Addendum No. 2, Oct. 23, 2026

Re: Tech Pride Room Renovation
Roaden University Center
Tennessee Technological University
TTU Project #27-009

2 TV BACKBOX MOUNTING DTL

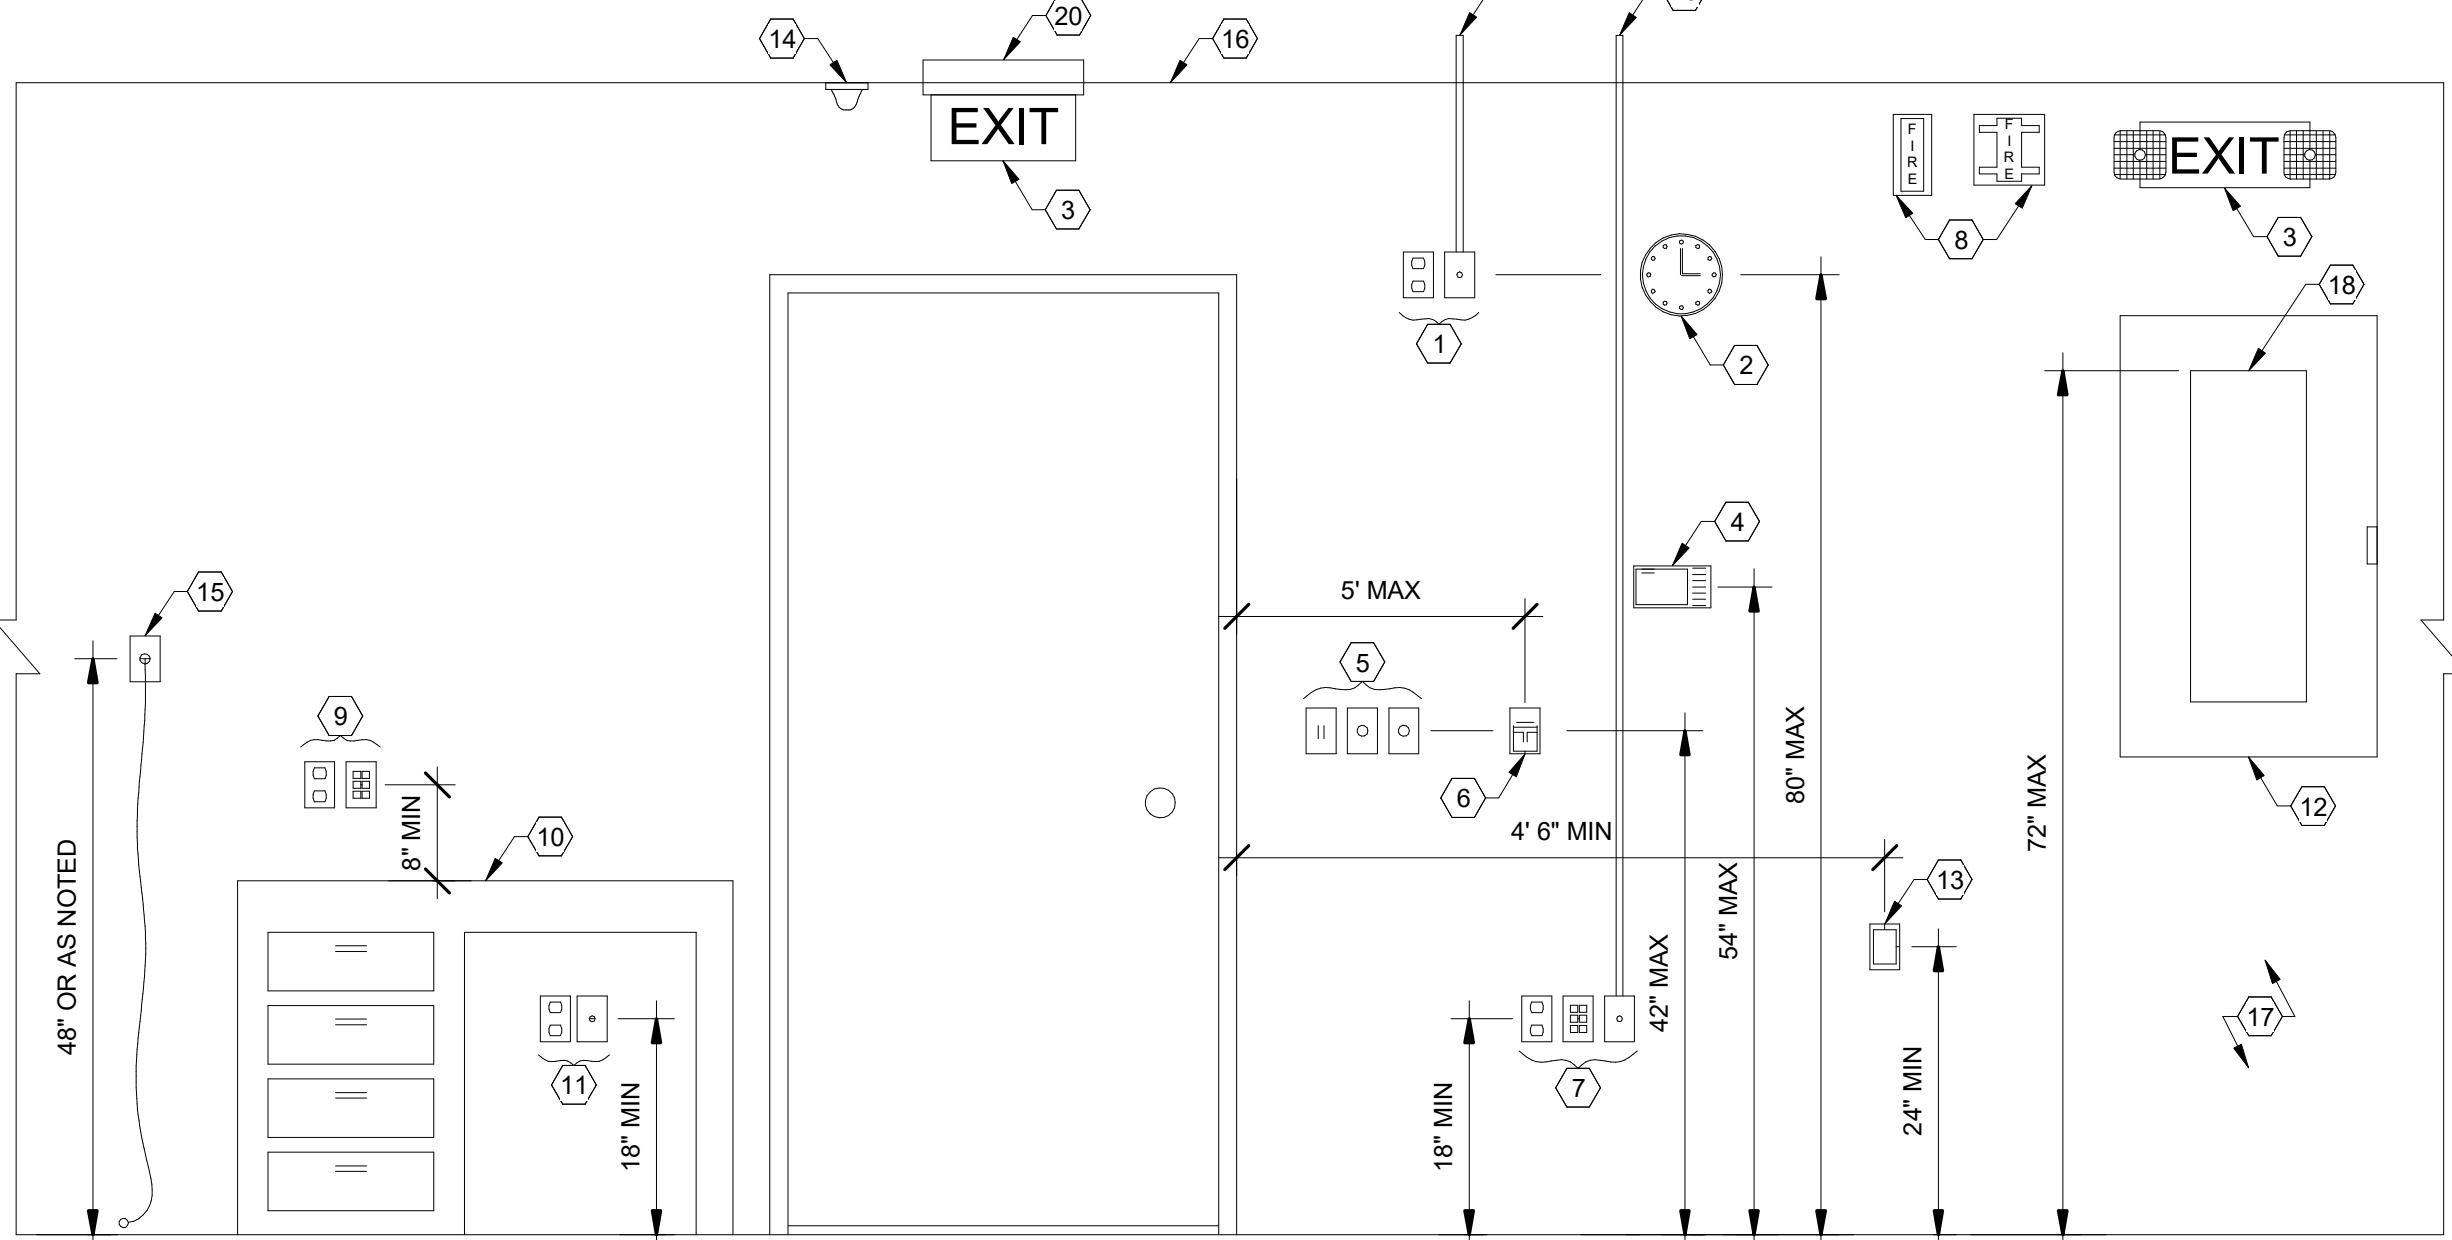
- 4) Refer to Drawing A1.1 Detail 2. Omit the 5/8" drywall on the cafeteria side of the new stud wall. Assume distance from top of existing CMU wall to underside of concrete slab above is 5'-0".
- 5) Refer to Drawing E0.1. Replace with attached Drawing E0.1, revised date 10/23/26.
- 6) Refer to Drawing E1.1. Replace with attached Drawing E1.1, revised date 10/23/26.
- 7) Refer to Drawing E0.1 Detail 2 TV Backbox Mounting DTL. The contractor is to provide and install the box only. The mounting arm will be provided by the Owner.
